ADDENDUM
NO. 2

April 20, 2021

HANOVER CENTRAL HIGH SCHOOL ADDITIONS AND RENOVATIONS
Cedar Lake, IN 46303

Addendum Two (AD.02) to the drawings and specifications prepared by Gibraltar Design and The Skillman Corporation for **Hanover High School Addition and Renovations** for Hanover Community School Corporation, Cedar Lake, Indiana.

SHEET ED104

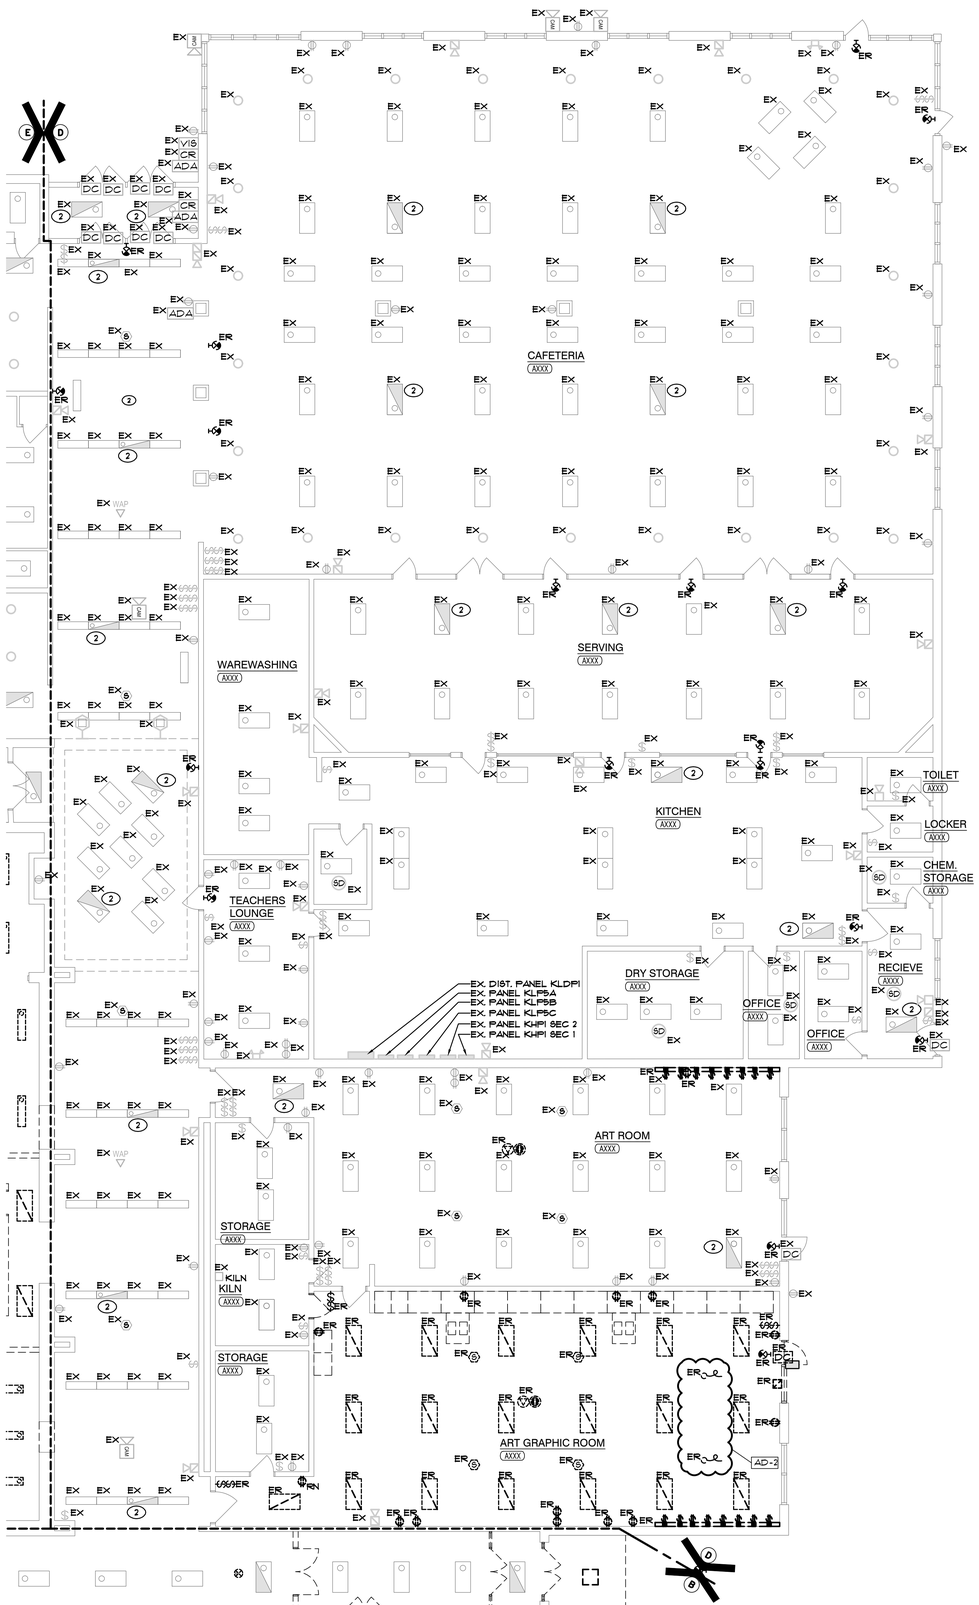
64. Sheet ED104

A. Refer to revised full-size drawing, included in this Addendum, for the following revisions:

1. Add disconnection and removal of (2) power poles for wiring devices in Art Graphic Room.

SHEET ED105

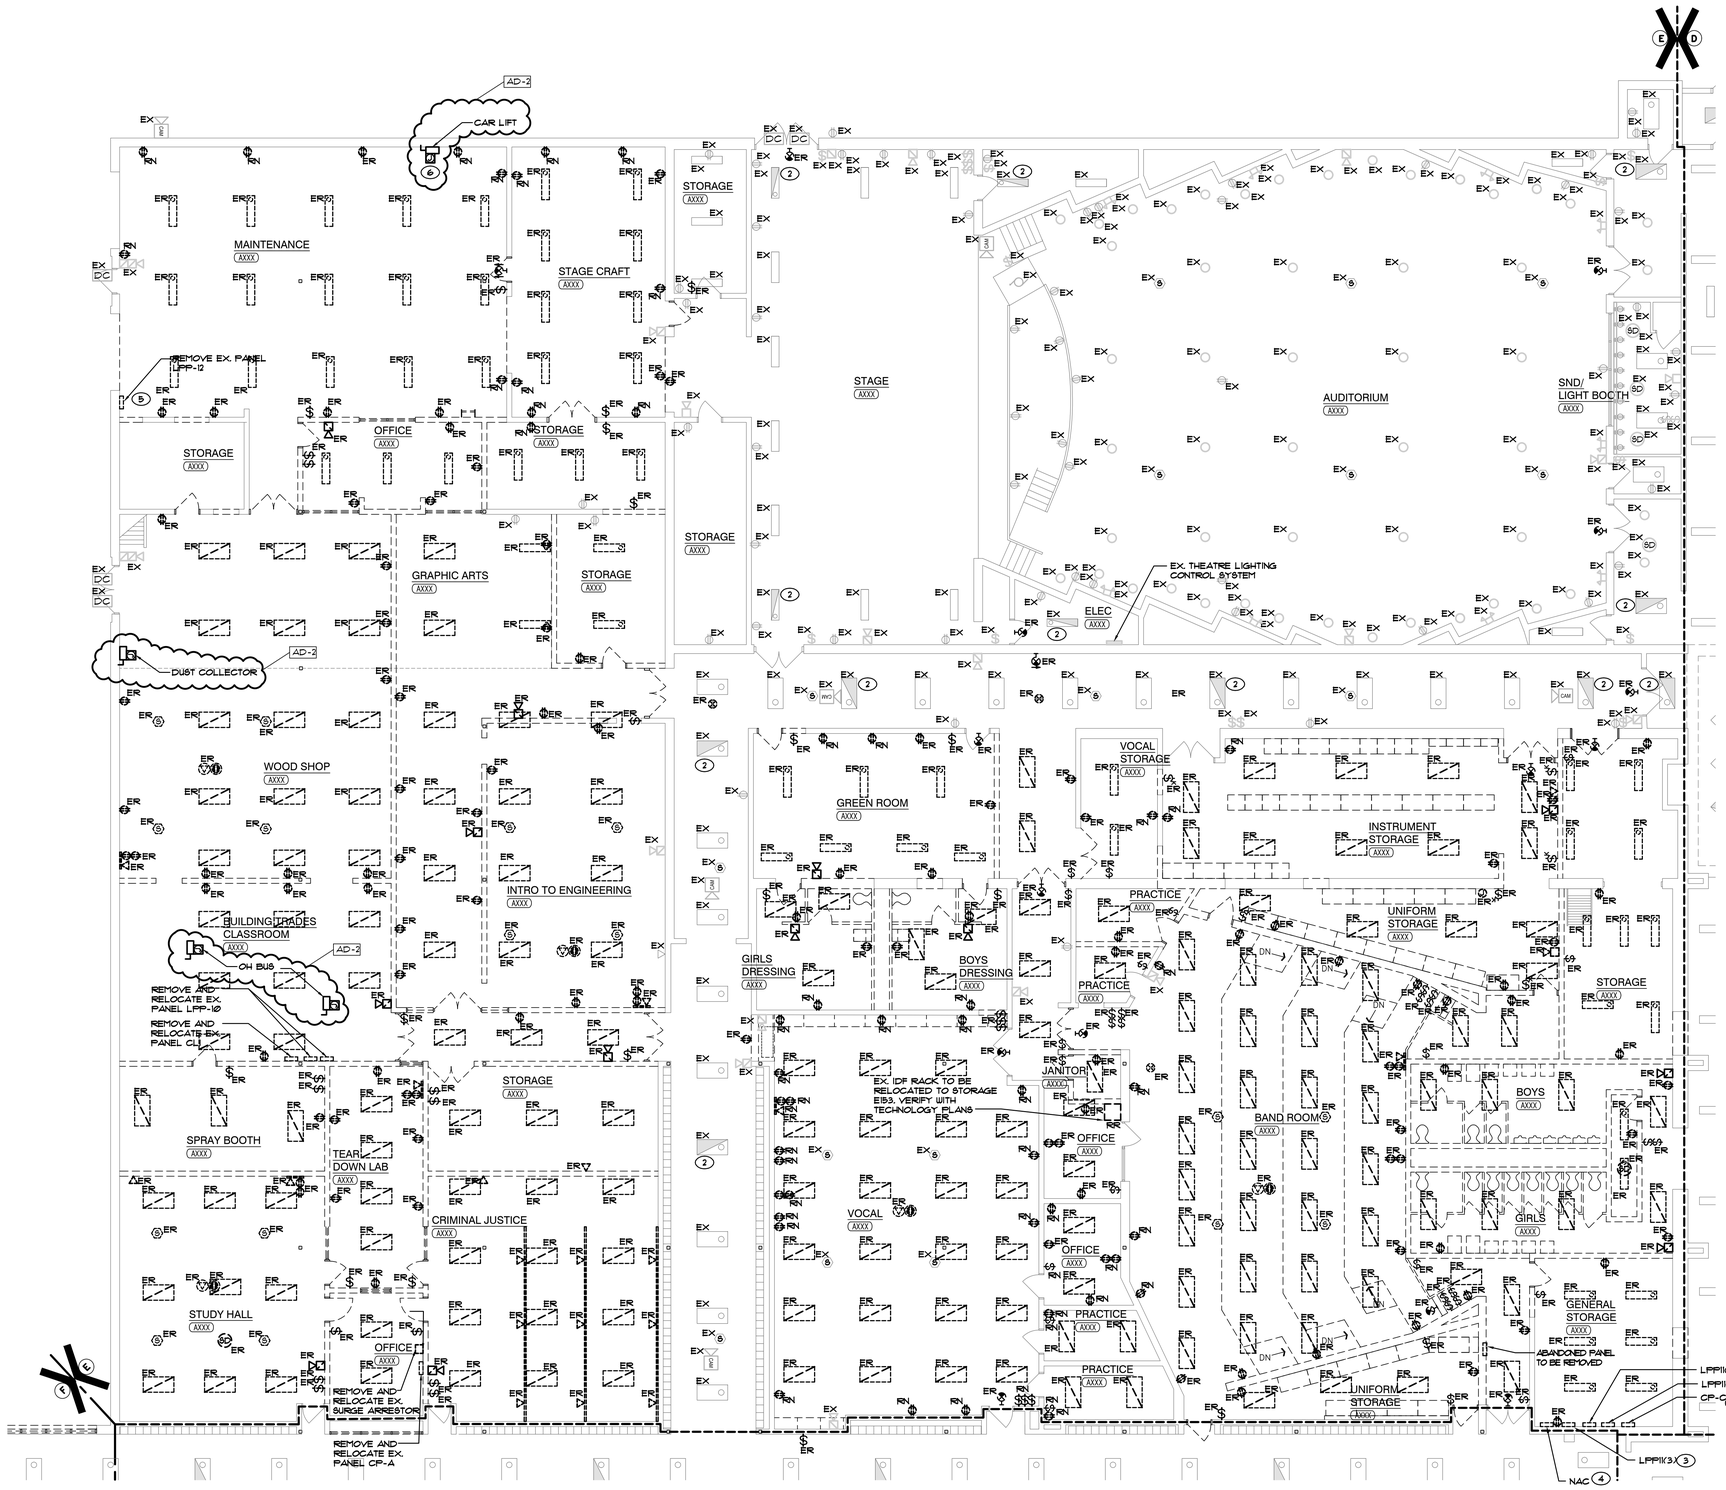
65. Sheet ED105

A. Refer to revised full-size drawing, included in this Addendum, for the following revisions:

1. Add disconnection and demolition of existing Car Lift, Dust Collector and OH Bus(Wood Shop)
